MODIFICATION SHEET NO. RDSO/WAM4/157**Modification in insulating ring (1218, 1219) fixing arrangement.****1. OBJECT**

MODIFIED CONTACT PLATE ASSEMBLY OF TAP CHANGER NO 32

SK.EL-3962

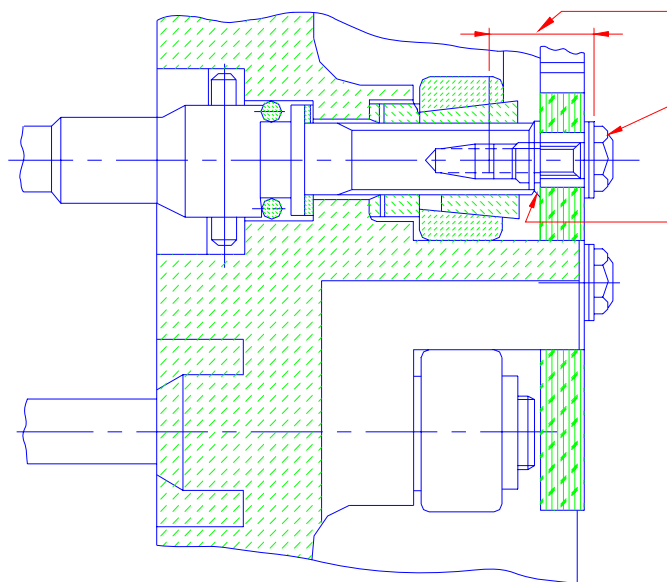
Railways have reported a few case of flashing over inside the selector housing assembly of tap changers. Investigations have shown that one of the reason for the flashing was intermediate contact terminals were touching the insulating ring. In case of copper deposition the chances of creepage between taps are more. In order to increase the path it is decided to provide an additional machined washers in between insulating ring (1218, 1219) and fixing contact terminal (1208, 1209).

- Dismantle the contact plate assembly.
- Replace the existing special bolt (1221) of 22 mm length with 24 mm length.
- Provide No.1 mm additional machined washer zinc plated $\phi 6.4 \times \phi 14 \times 1$ in between insulating ring and the stud at the screwing points.
- Reassemble the contact plate.

MODIFIED SPECIAL BOLT P.NO.1221
LENGTH=24mm.
MODIFIED SPECIAL BOLT P.NO.1221
ADDITIONAL MACHINED WASHER
 $\phi 6.4/14 \times 1$ ZINC PLATED
